## Staff Report

**Meeting Date:** January 12, 2023 (Prepared January 5, 2023)

**Item:** ANX 22-03, PP 22-02, SUB 22-04, VAR 22-07, & ZMC 22-03 "Brighton Pointe Subdivision" at 8708 Parr Road NE

**TENTATIVE SITE PLAN**  
SCALE: 1" = 80'

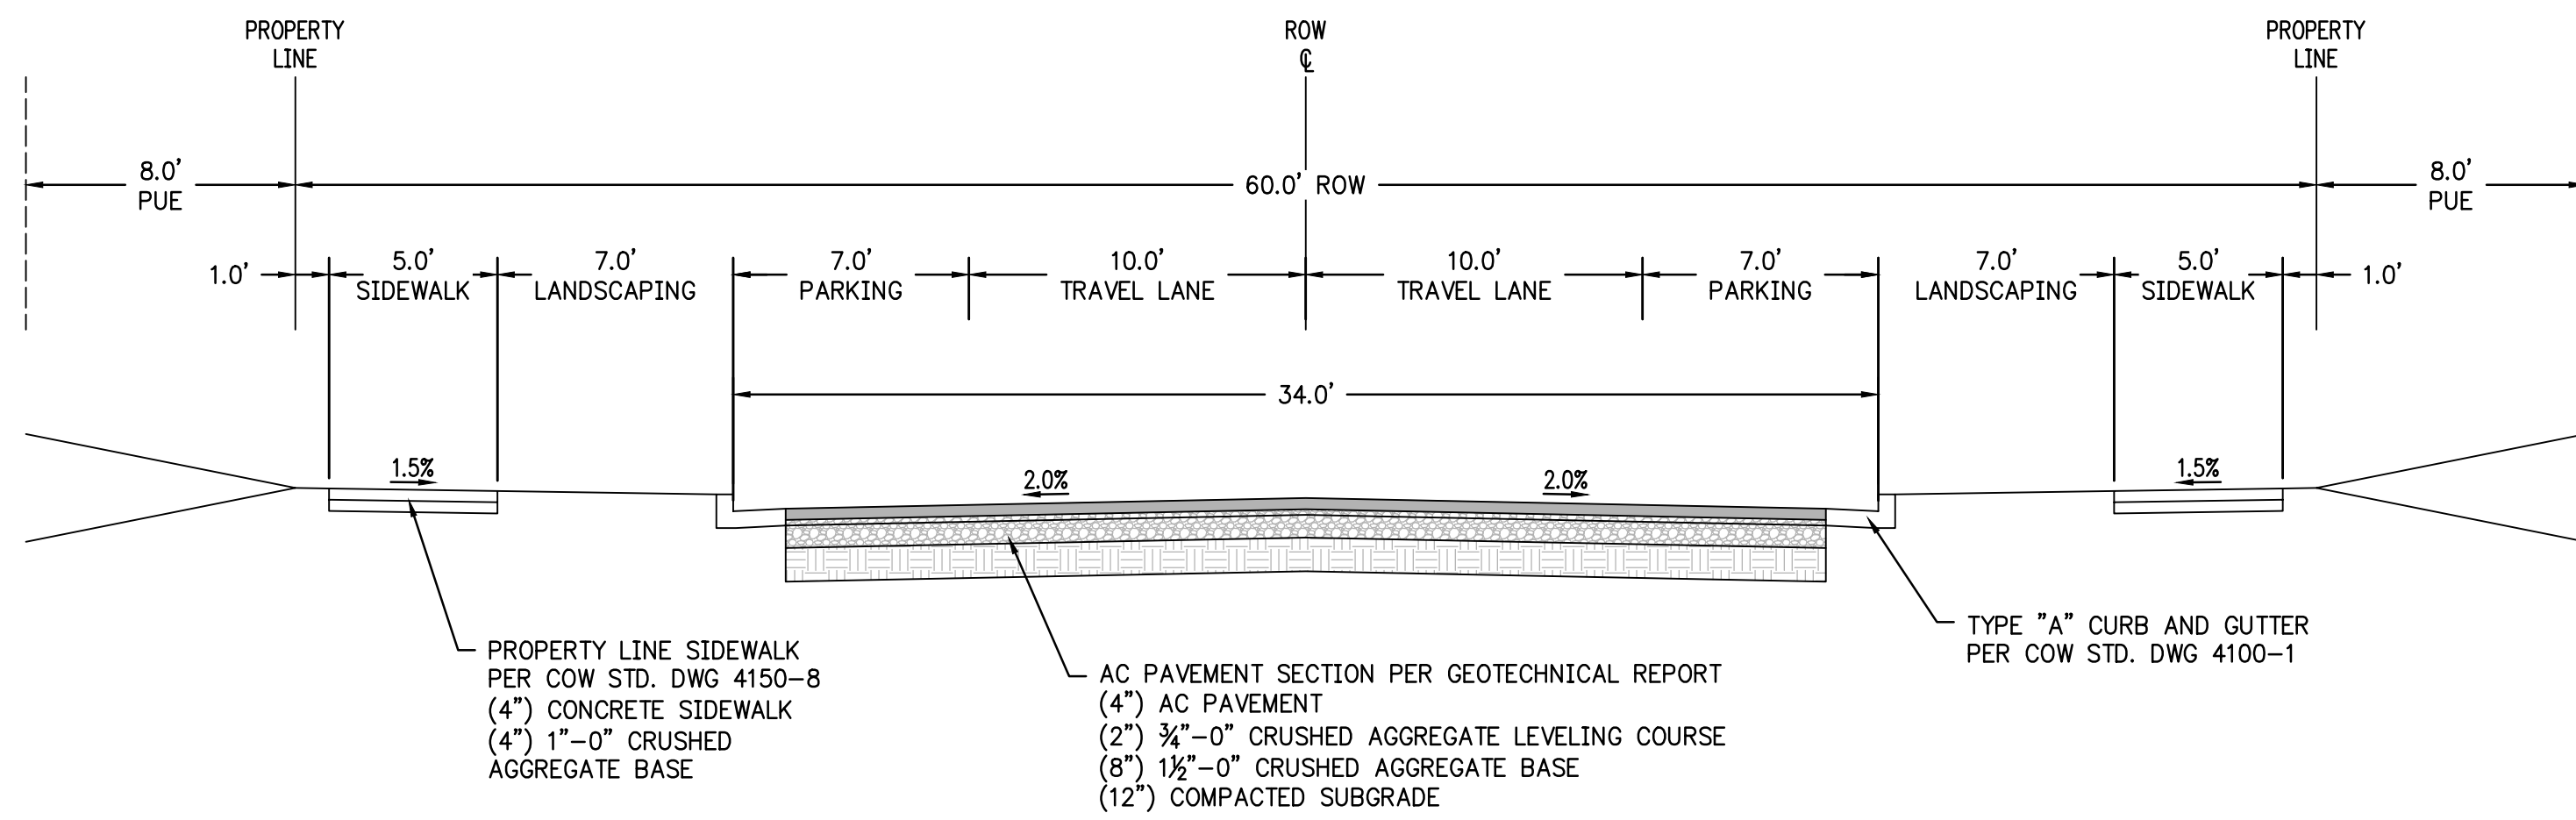
23. Alley access onto Parr Road: The developer shall revise plans to close the alley access onto Parr Road, unless such access is required by the Woodburn Fire District. If required by the Fire District, the driveway shall utilize a mountable curb instead of a standard driveway approach. The area between mountable curb and sidewalk shall be paved, and removable bollards shall be installed on the portion of driveway on private property within 10 feet of the front property line. The final design of the improvements for this driveway shall be to the satisfaction of the Community Development Director, the Woodburn Fire Marshal, and Marion County.

**4 ALLEY 1, 3, AND 4 - TYPICAL SECTION**  
 4 1" = 5'

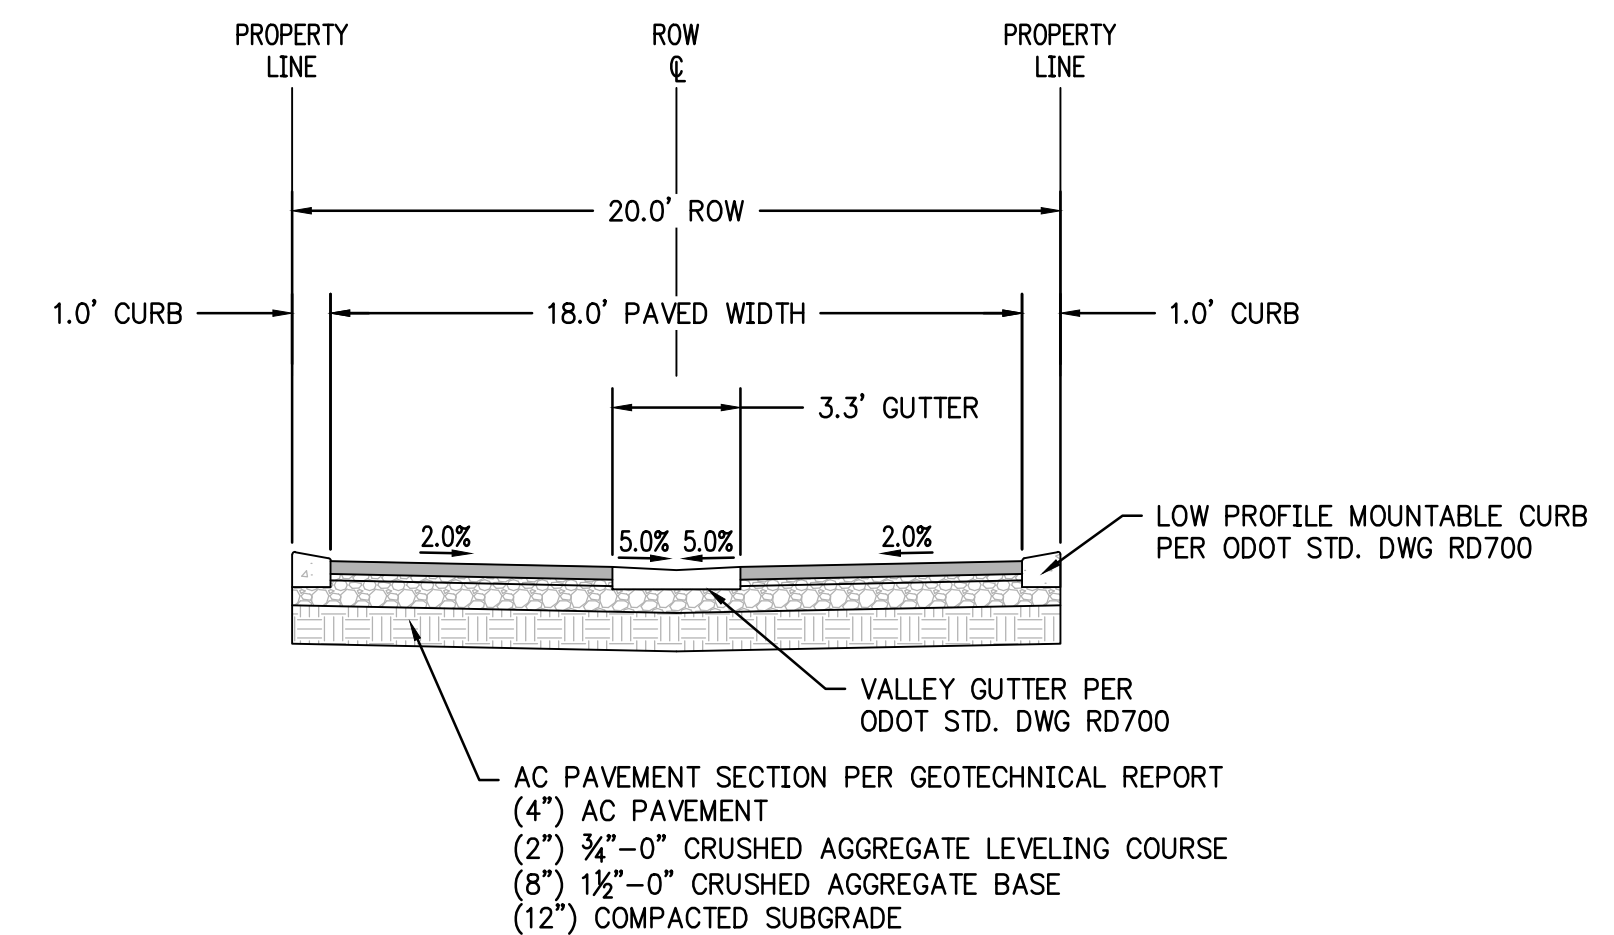
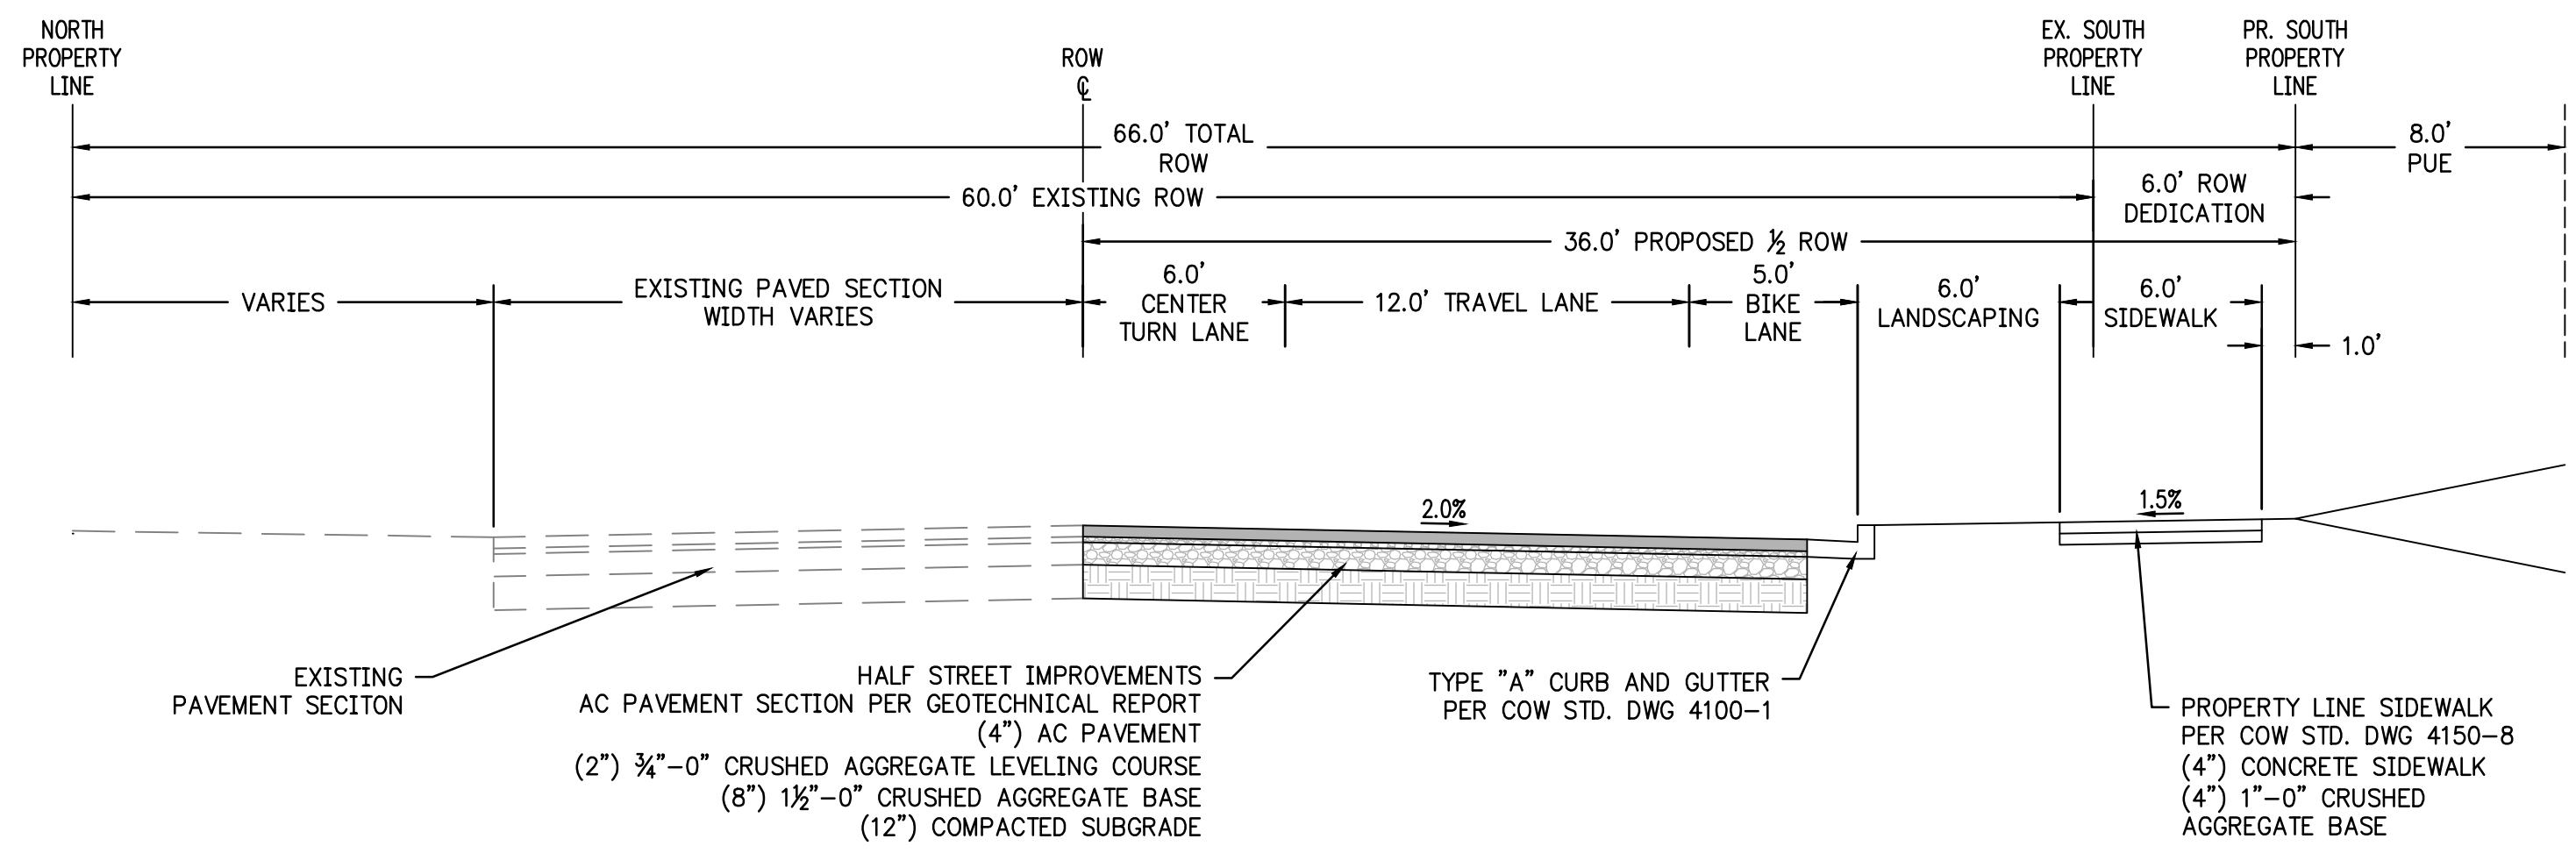
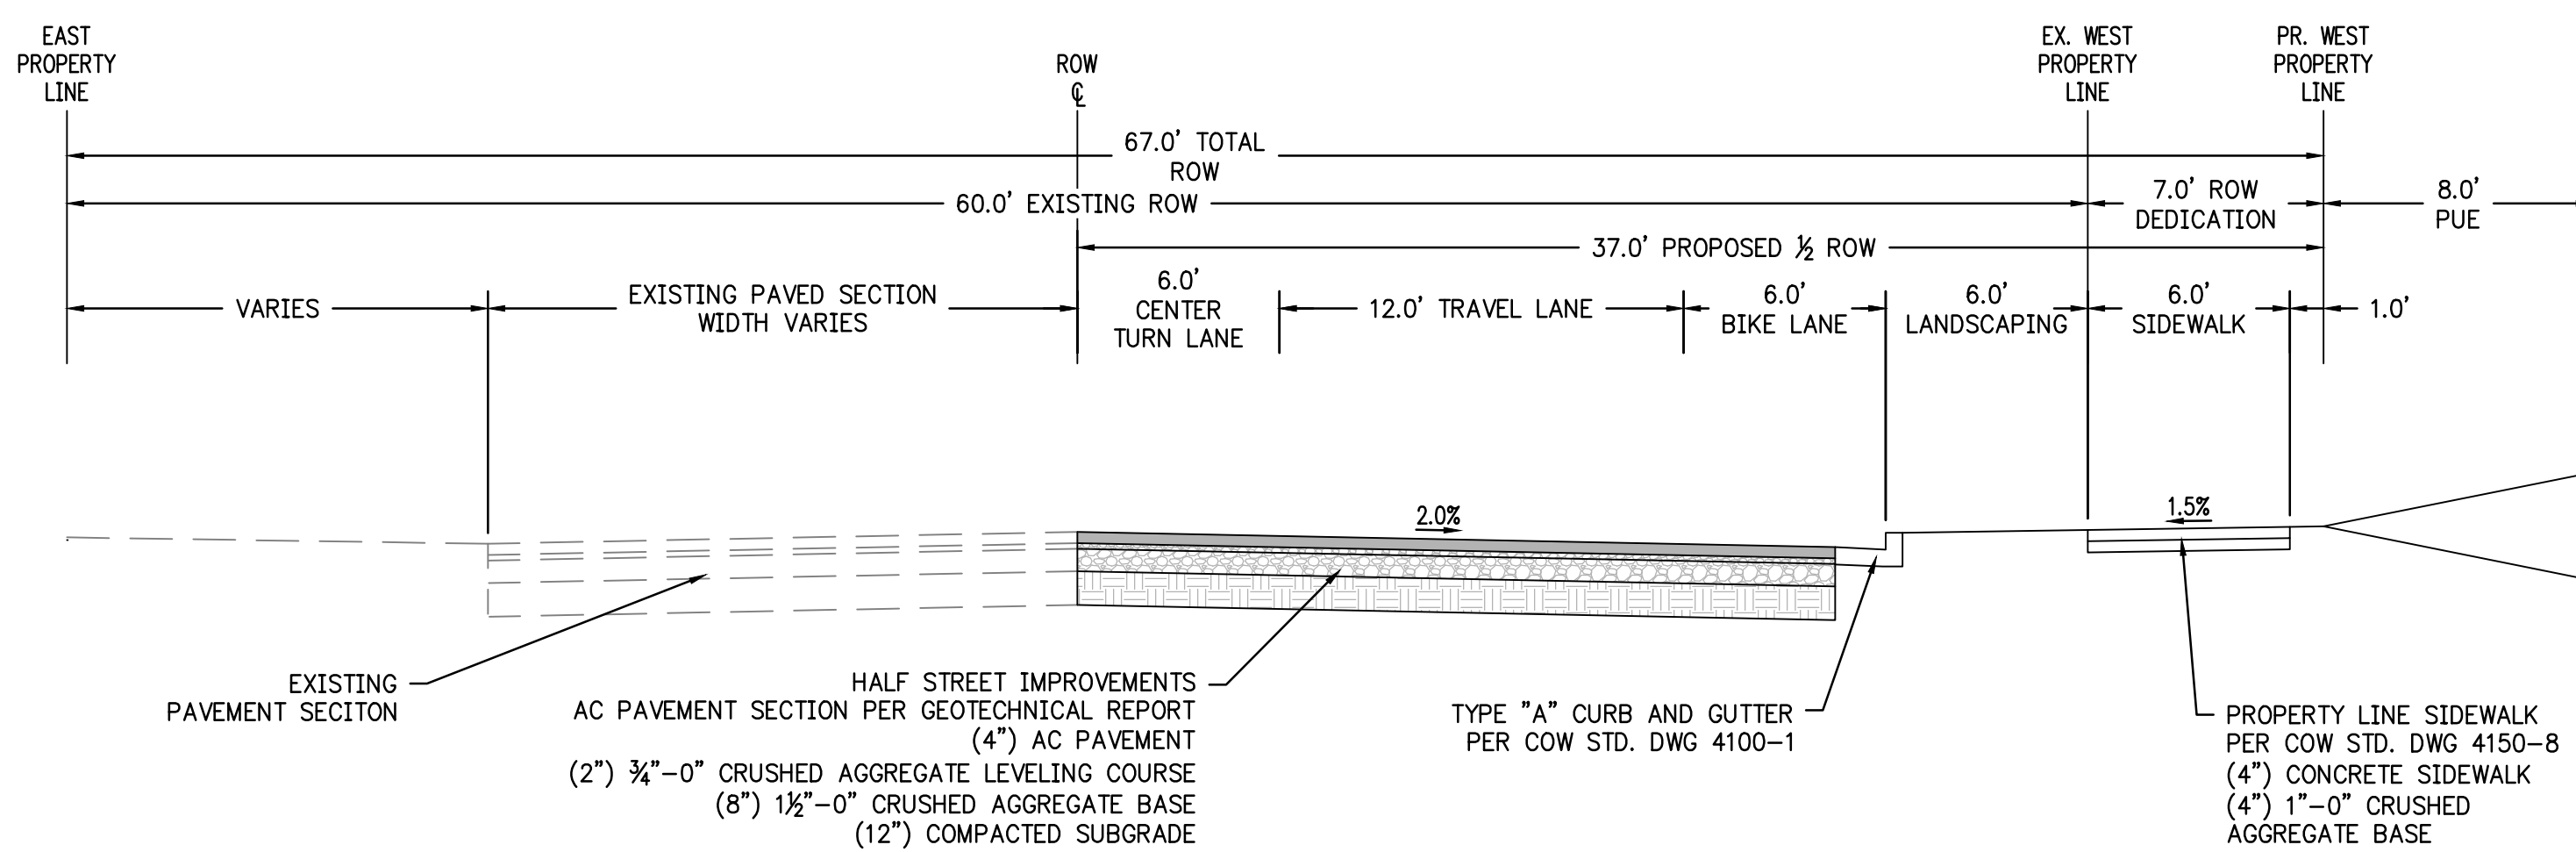
22. Alleys: All alleys shall be within tracts that are privately owned and maintained. Alley improvements shall match the cross-sections provided by the applicant on Sheet 5 of the approved preliminary plans. The landscape buffer within the alley abutting 8702 Parr Rd (Tax Lot 052W130001000) shall have a planting density in conformance with WDO Table 3.06A "Setbacks abutting a street".
